Addendum No. 2
Solicitation 25-99328
Junction Avenue and St. Marie Street Reconditioning

NOTICE

JUNCTION AVE/ST. MARIE ST. RECONDITIONING

SHEET NO. DB04 OF DB14 SHEETS

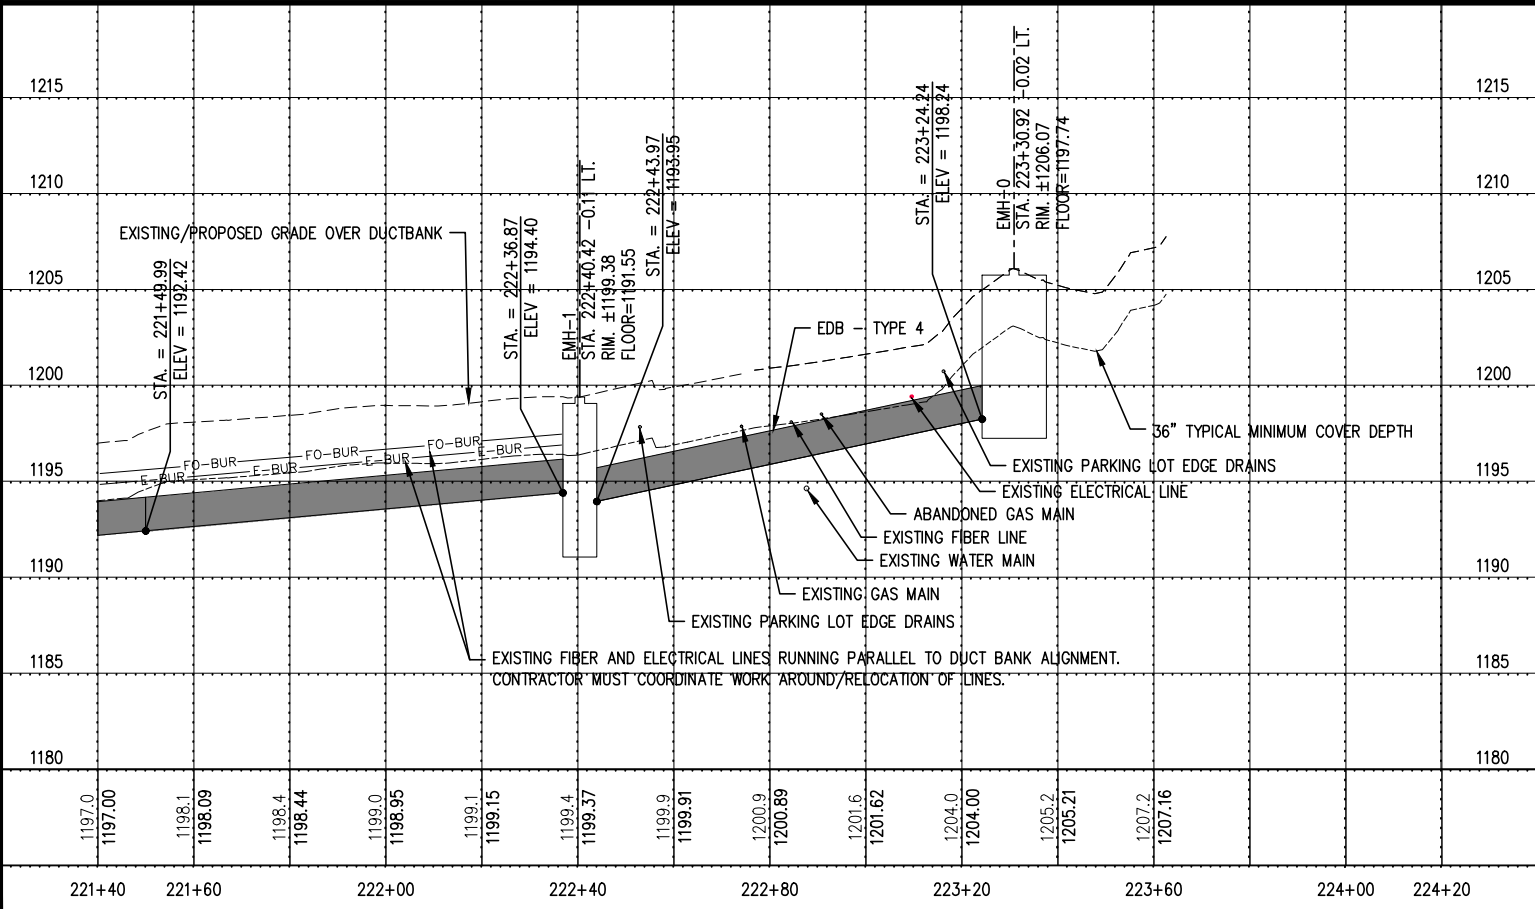
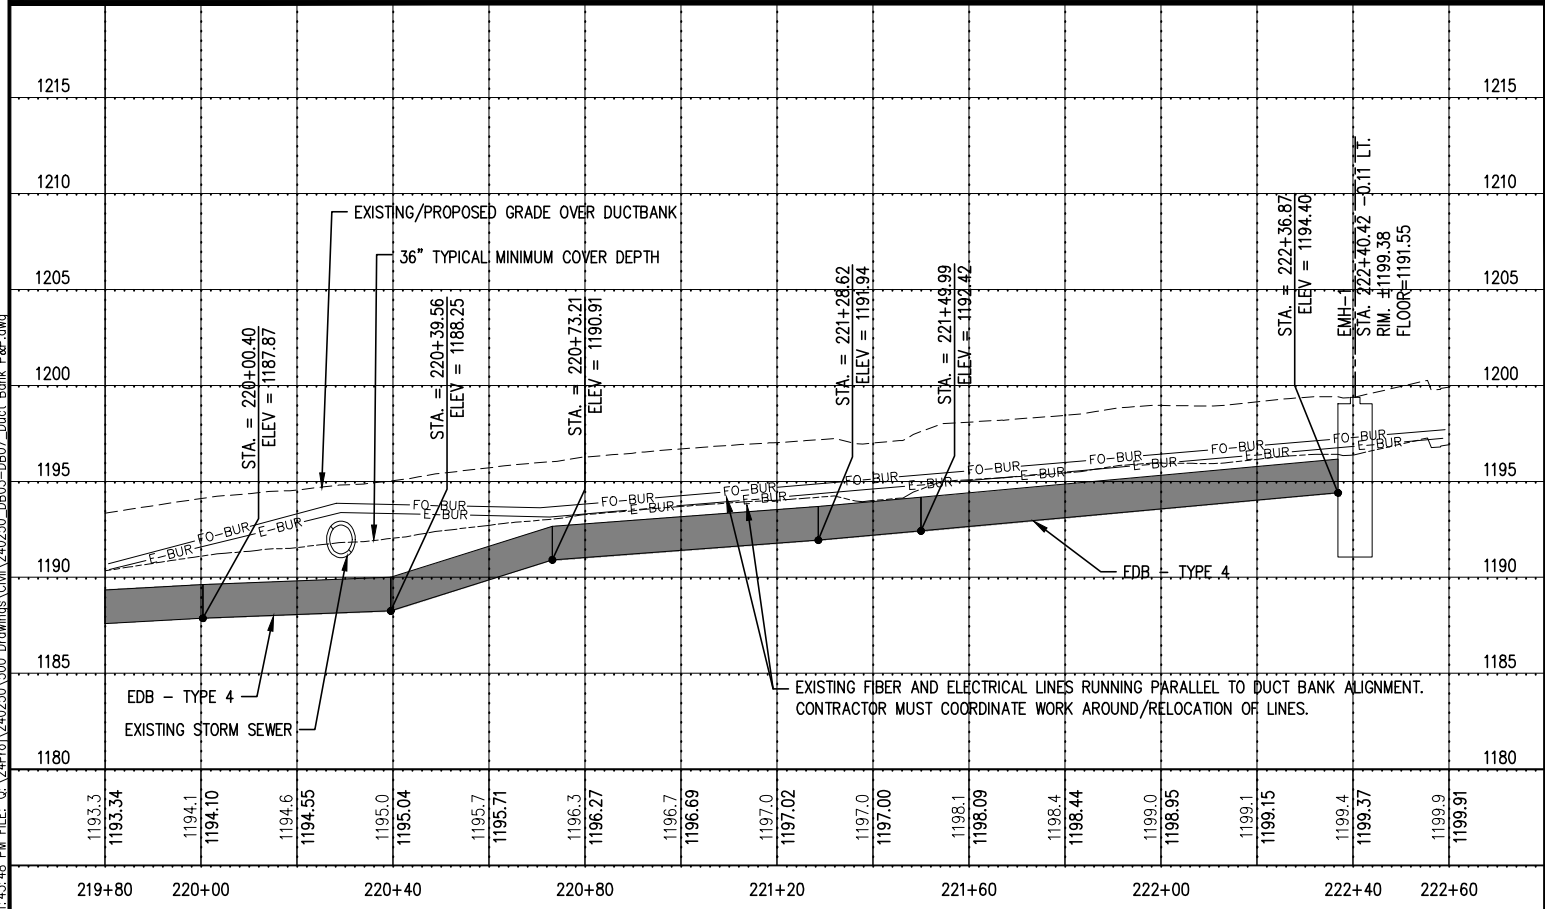
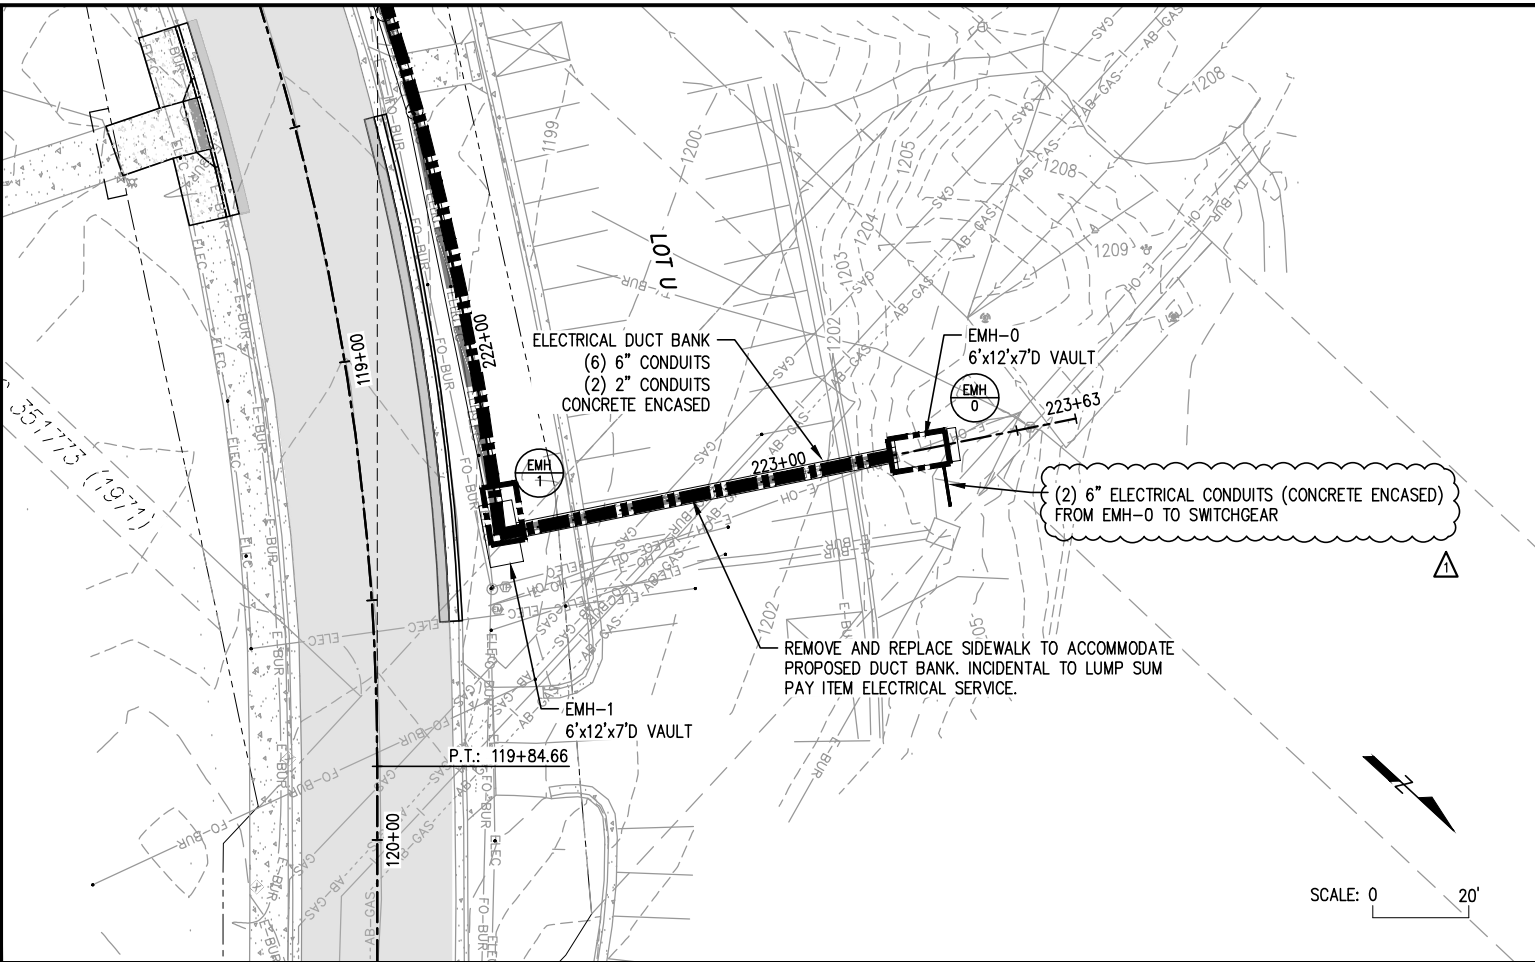
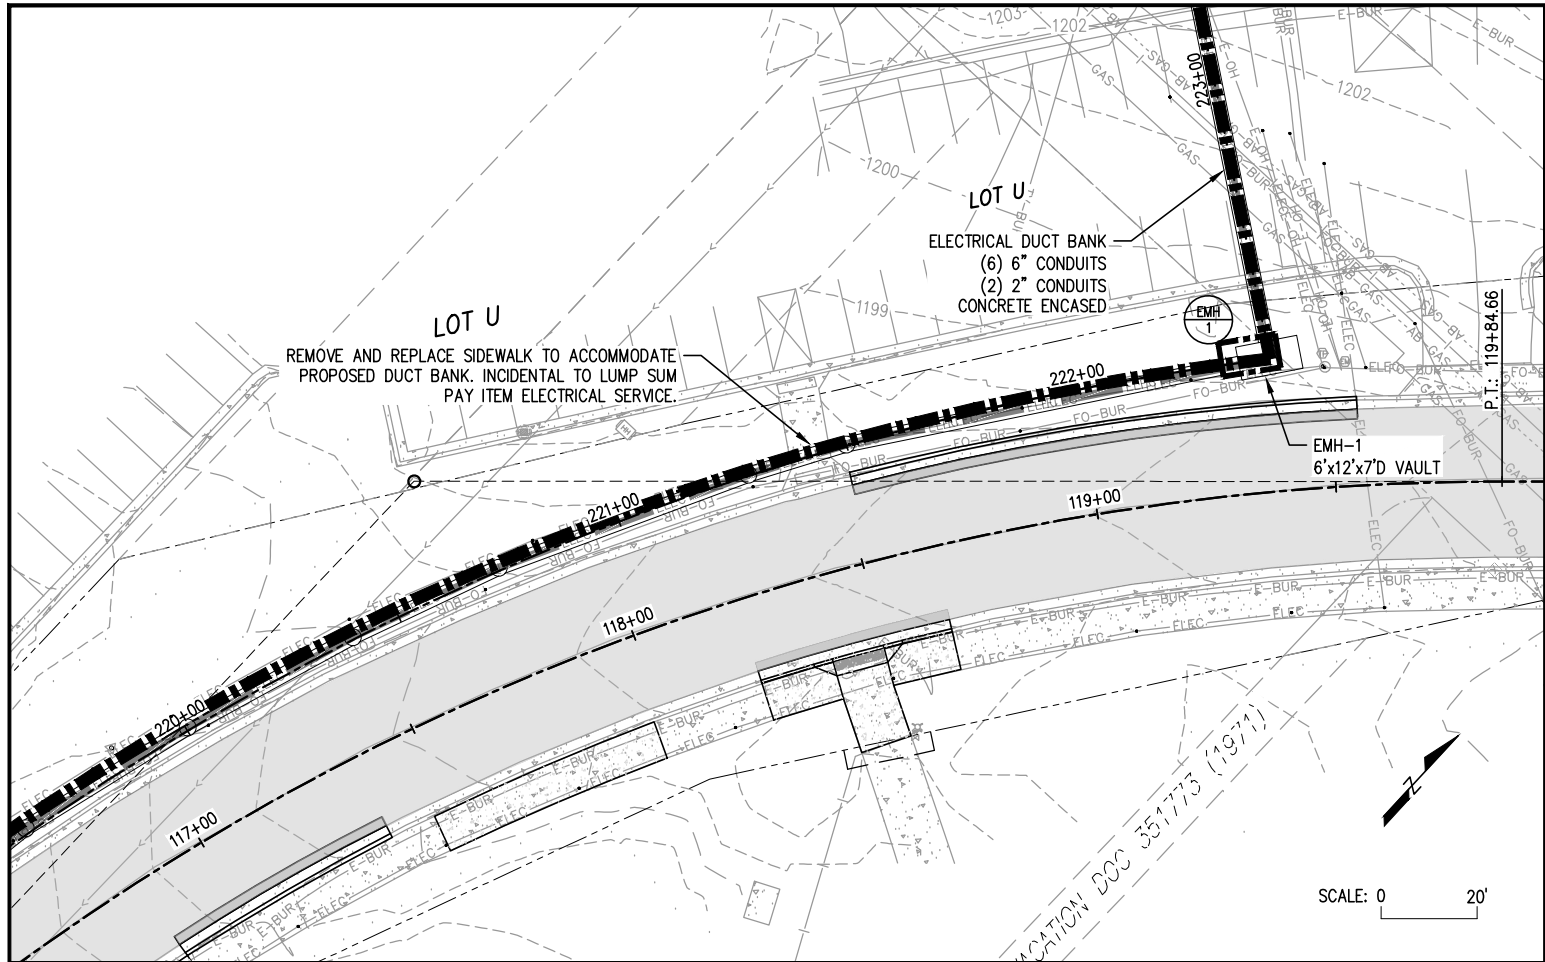
- c. Sheet DB04; Delete Sheet DB04 in its entirety and replace with revised Sheet DB04.
Revisions to Sheet DB04 are as follows:
 - i. Amended note “ESG-1 SWITCHGEAR” to include “ROUTE (1) 6” CONDUIT IN/OUT OF ESG-1

- ii. Added items:
 - 1. DIRECTIONAL DRILL (1) 4” CONDUIT TO APARTMENTS
 - 2. DIRECTIONAL DRILL (1) 4” CONDUIT TO FIREHALL
- d. Sheet DB07; Delete Sheet DB07 in its entirety and replace with revised Sheet DB07.
Revisions to sheet DB07 are as follows:
